## SERVICE BULLETIN

Bulletin N° 005/Feb/10

All ISP manufactured products including Lifejackets and Bladder Assemblies fitted with **HALKEY ROBERTS BLACK MOULDED MANIFOLDS**

Notification of Instruction For Use Bulletin issued by the Manufacturer of **HALKEY ROBERTS BLACK MOULDED MANIFOLD**

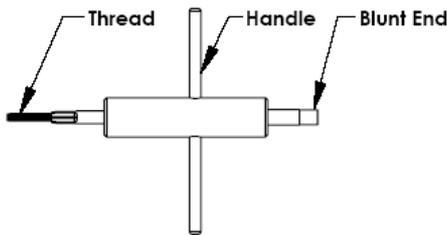
If replacing the valve core assembly on an ISP manufactured product and the manifold is the black coloured moulded type (Photo 1), the valve core can be replaced using the procedure in the following 'Instruction For Use' notice on sheet 2 issued by Halkey Roberts, the manifold/valve manufacturer.

illustration 1

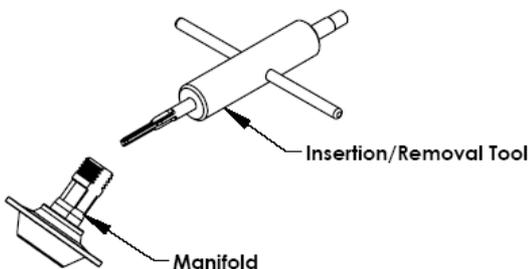
1. Insert threaded portion of valve core insertion/removal tool into manifold, ill. 1.
2. Screw tool clock-wise into valve core approximately 3 turns.
3. Holding manifold flange, pull tool out to disassemble valve core from manifold body.
4. Unscrew old valve core from tool and discard.
5. Inspect inside bore of manifold to be sure that silicone sleeve has been fully removed.

illustration 2

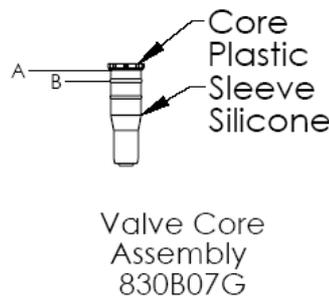
Prior to assembly check the new Valve core assembly to insure the top of the clear sleeve is between points A, and B on the green plastic core. ( See illustration 2. )

1. Insert new valve core assembly (830B07G, ill. 2) into manifold with open end facing out.
2. Use blunt end of valve core insertion/removal tool to fully insert valve core. The tool should nearly touch the top of the manifold.
3. Using a calibrated depth gauge, the depth to the valve core must meet the callout in ill. 3.
4. Repeat step 2 and step 3 as necessary.
5. Perform normal air retention test on bladder.
